**FILING 19 - 32ND AVENUE
 (BETWEEN N. IRVINGTON ST. TO TAH PARKWAY)
 AT THE AURORA HIGHLANDS
 SITE PLAN**

32ND AVENUE
 AT THE AURORA HIGHLANDS
 SITE PLAN

COVER SHEET

DATE: DECEMBER 2022

SITE PLAN CHARTS

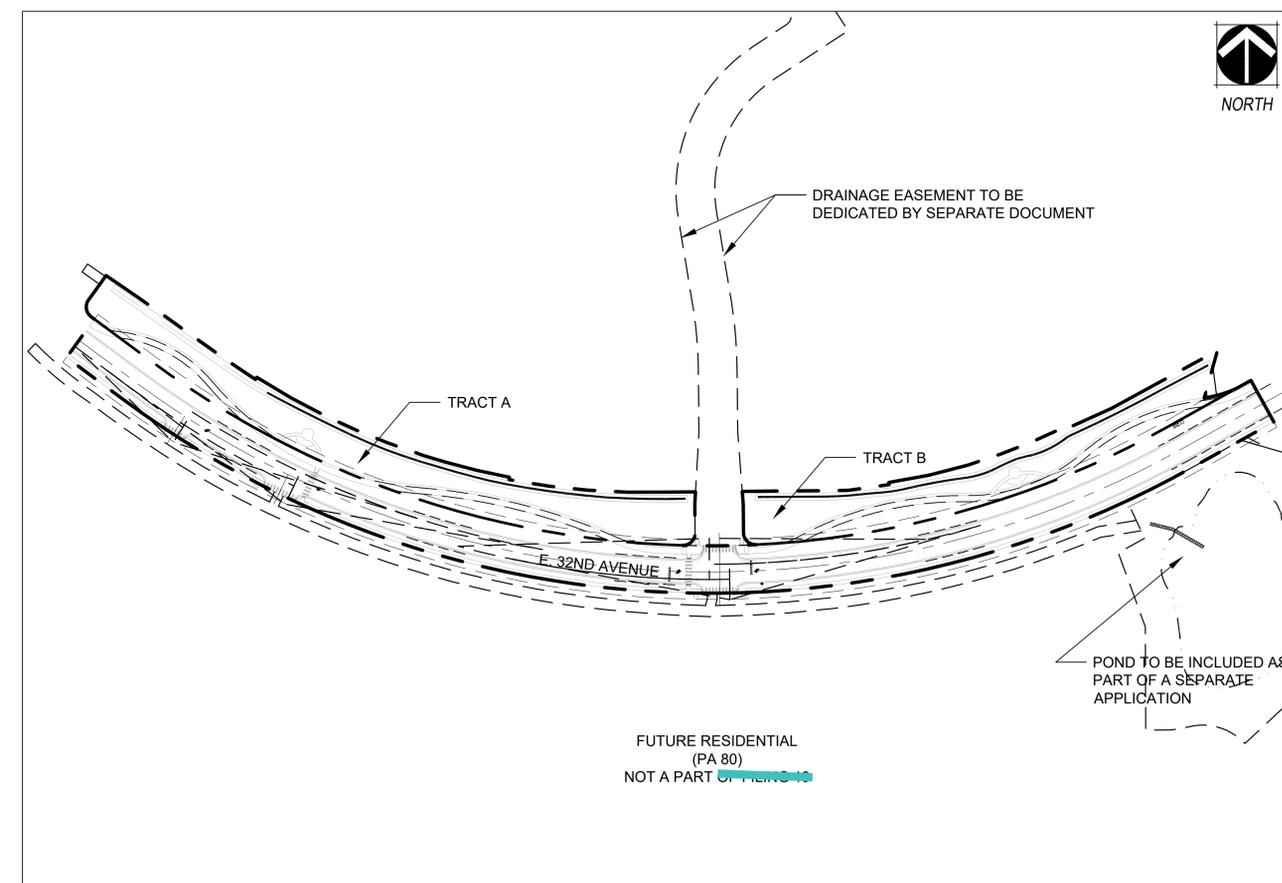
repeat comment. Site Plans are not all named same as sub plat #. Put in site plan names.

Response: Updated on new sheets with correct site plan naming

OVERALL SITE PLAN

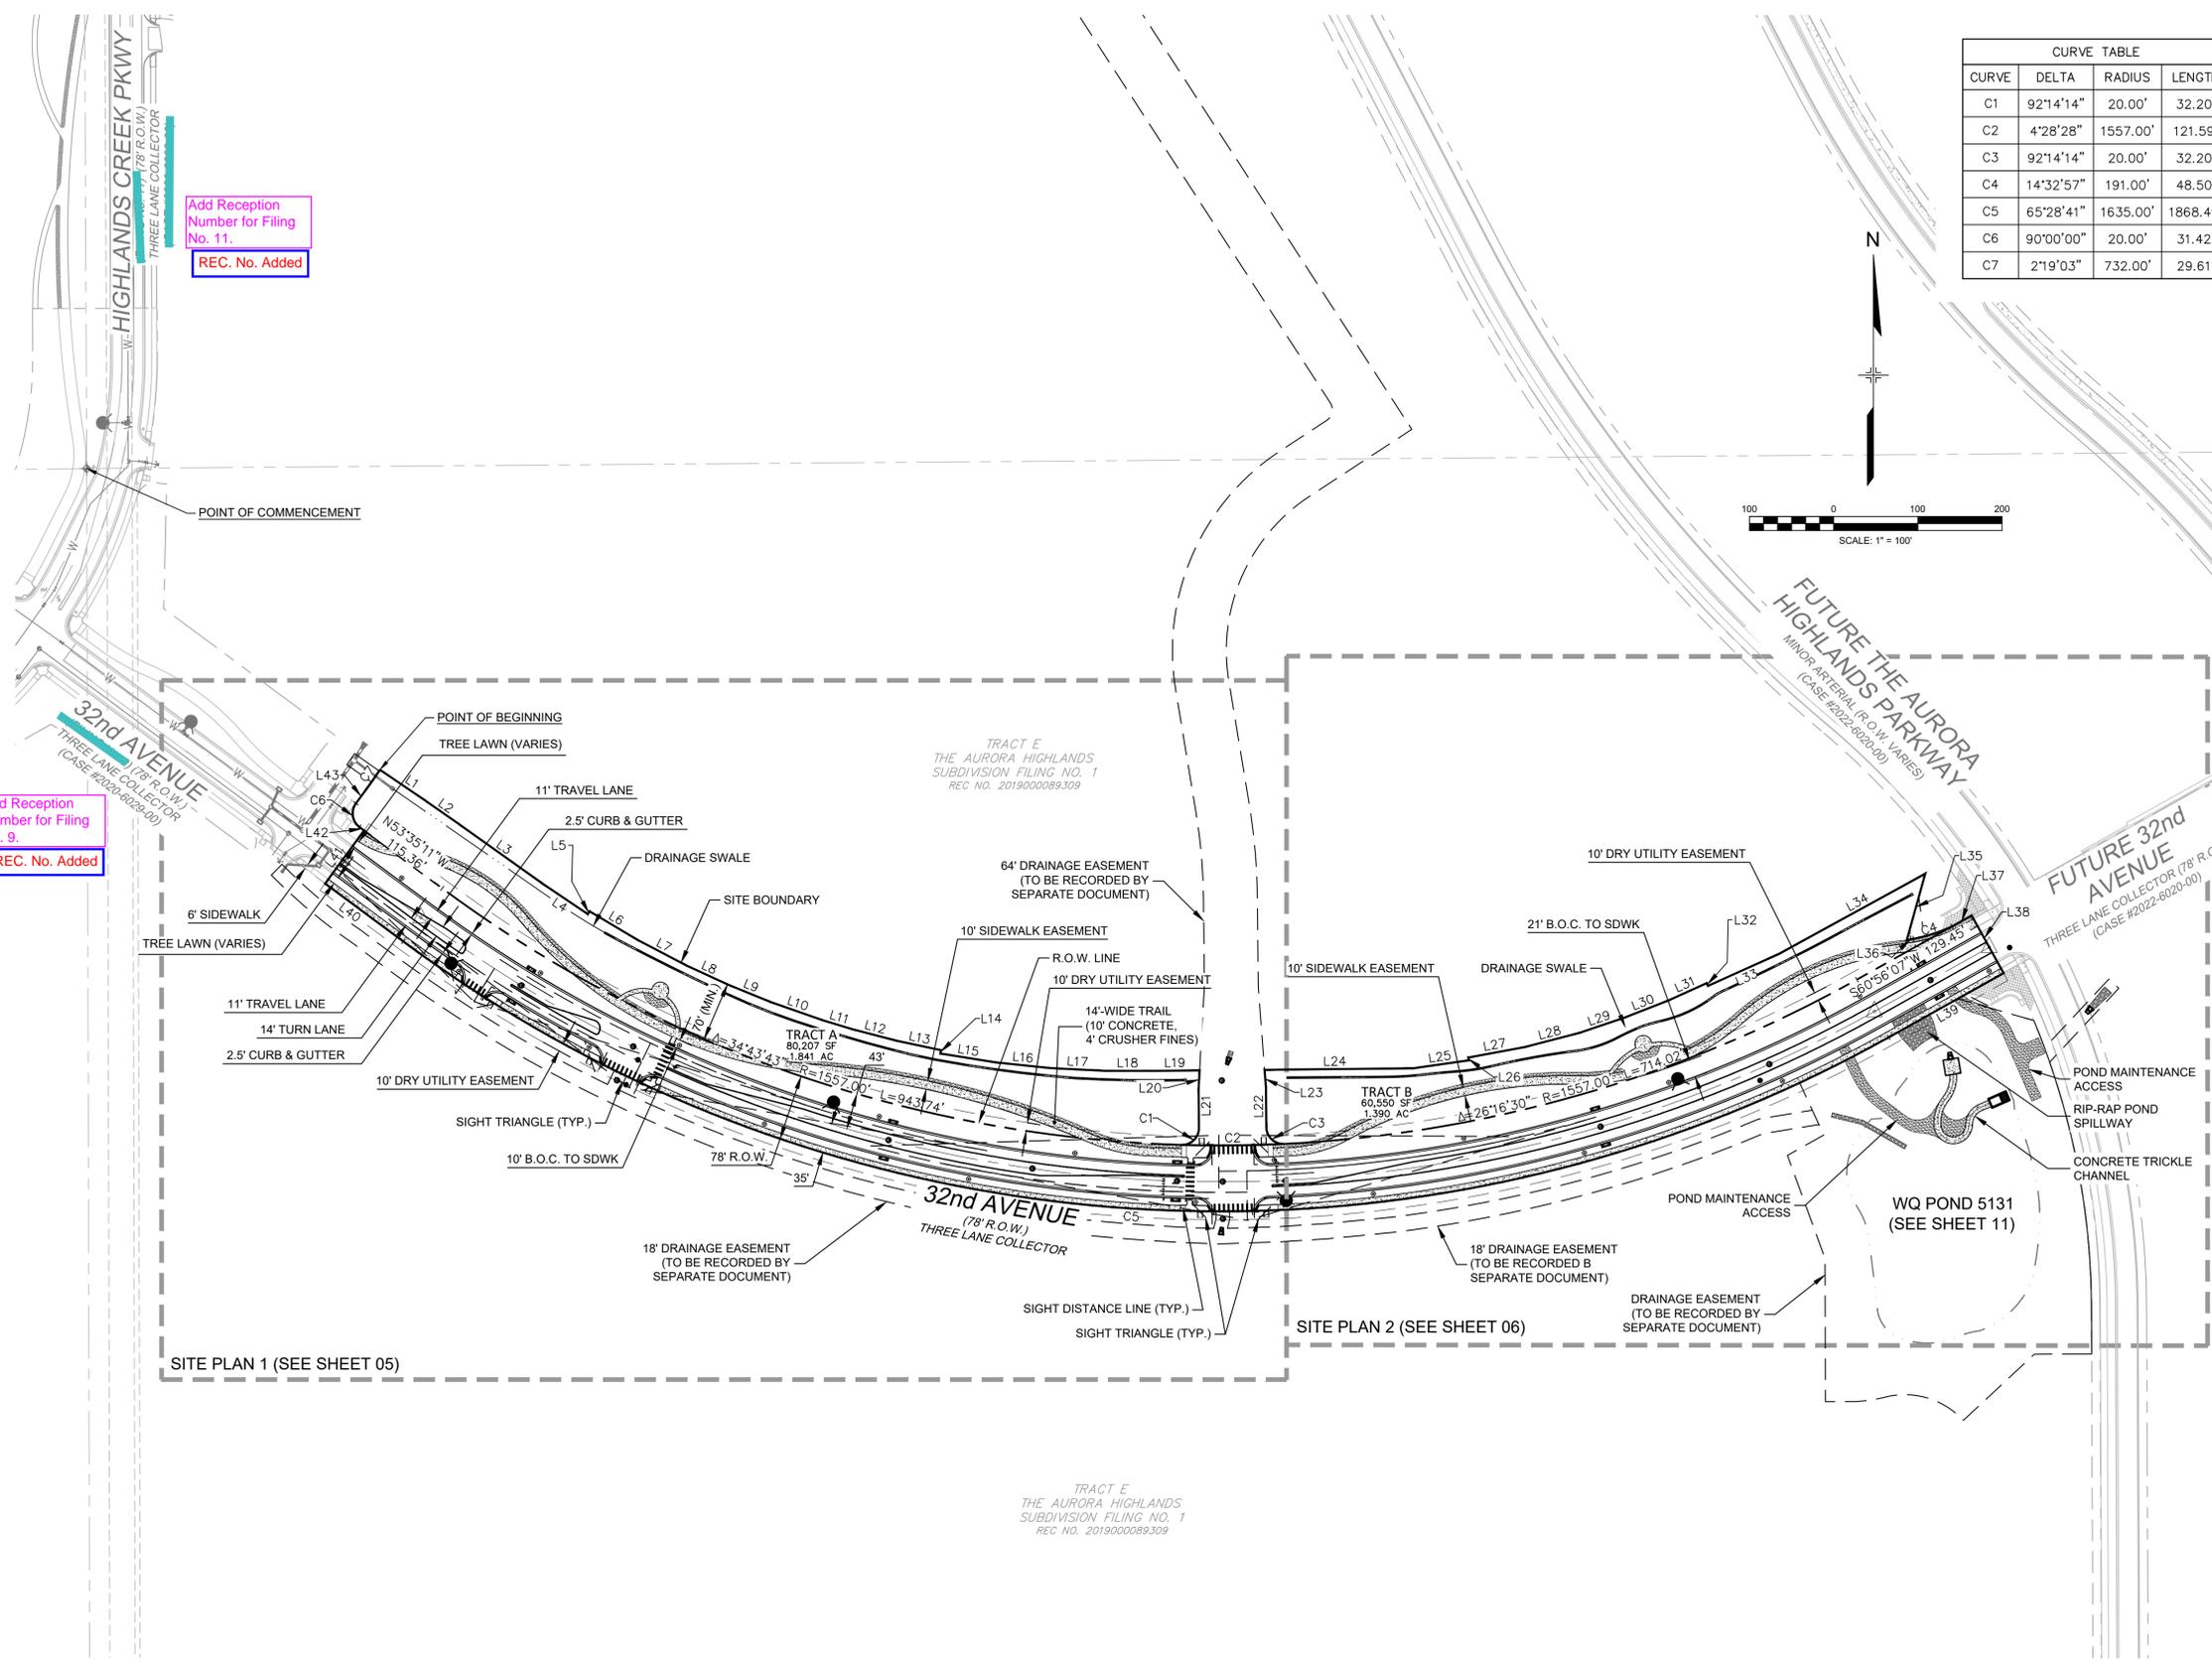
Add Reception Number for Filing No. 11.
REC. No. Added

Add Reception Number for Filing No. 9.
REC. No. Added

L1.01 - PLANT SCHEDULE
 SHEET: 13 OF 22

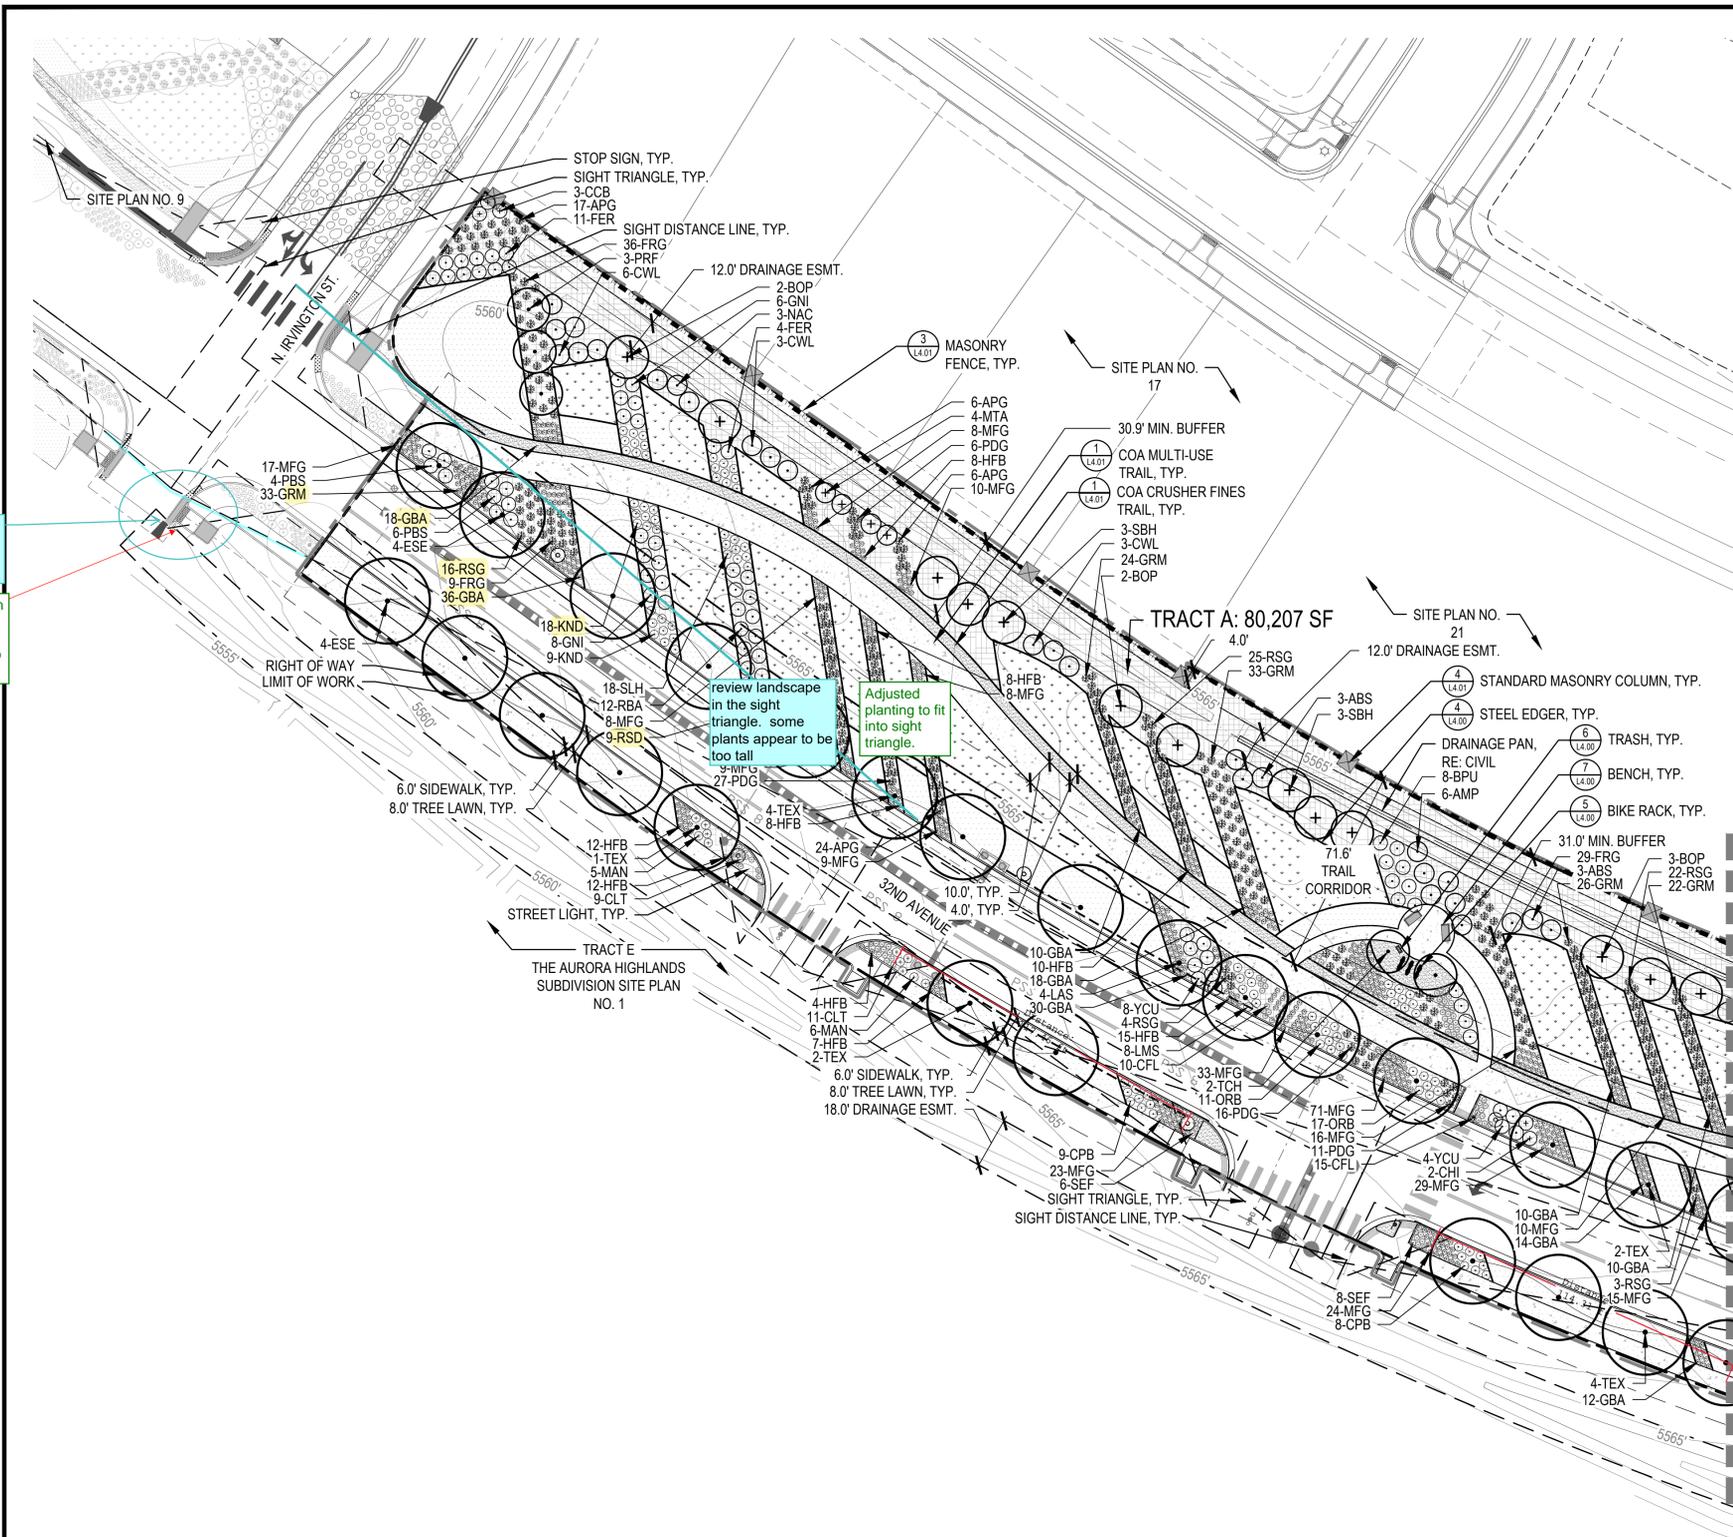
landscape comments:
 1. Review height of plant material in the sight triangle
 2. make sure all symbols are in the legend

Adjusted planting to fit into sight triangle.
 Symbols have been added.

Adjusted planting to fit into sight triangle.

Adjusted planting to fit into sight triangle.

L2.00 - LANDSCAPE PLAN
 SHEET: 14 OF 22

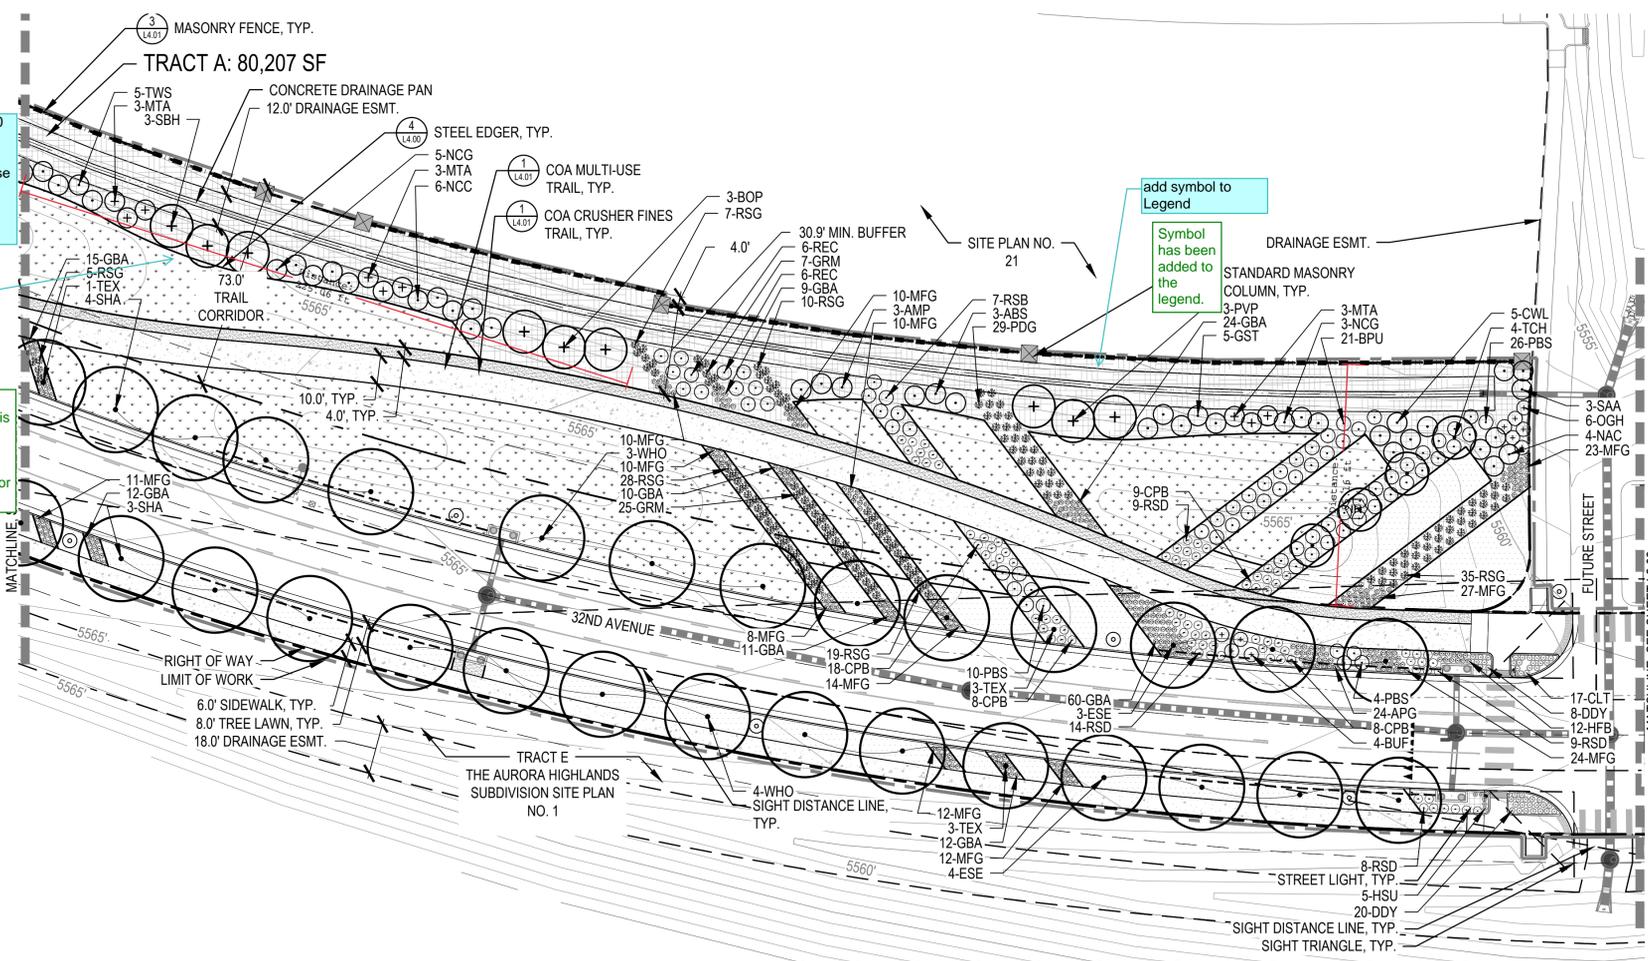
where is the stop sign? typically required behind crosswalk

Stop sign is hidden by easement linework. Label has been added to help identify.

L2.01 - LANDSCAPE PLAN
 SHEET: 15 OF 22

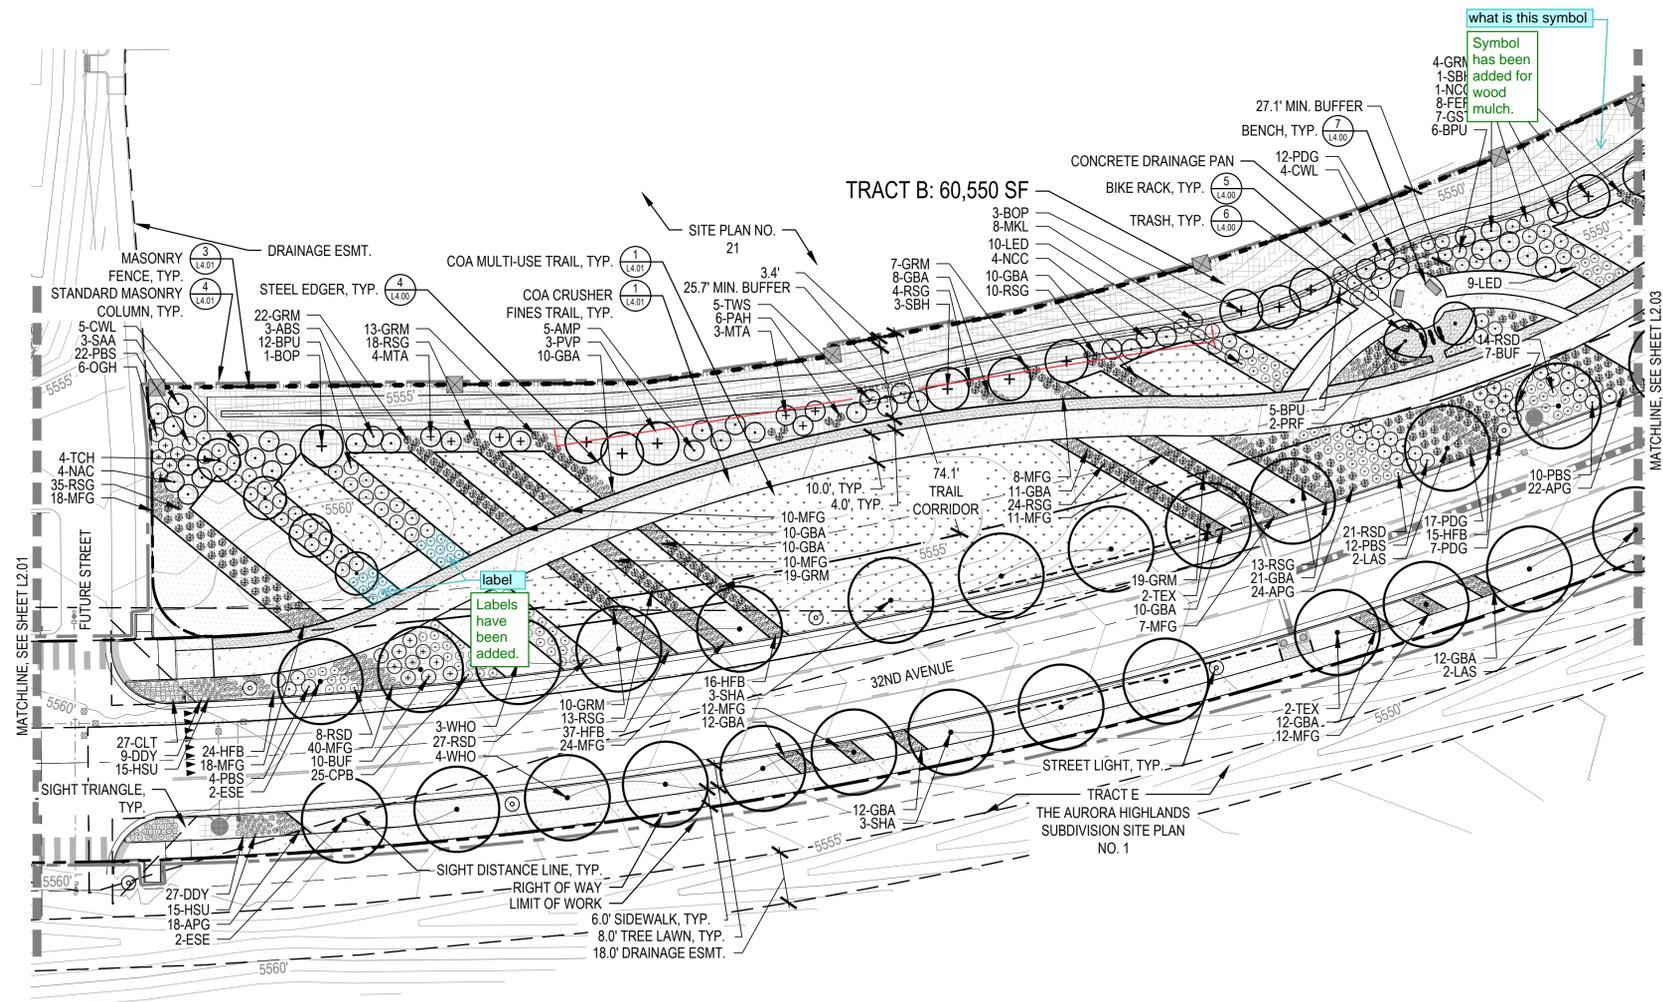
Thank you for the comment.
 Buffer is 1 tree/1- shrubs per 40 LF. plant material should be distributed more evenly. No major changes required because this is a late comment, but for consideration.

add symbol to Legend
 Symbol has been added to the legend.

Thank you for the comment. Overall buffer is still being met, but the comment above is understood and will be taken into consideration for future filing submittals.
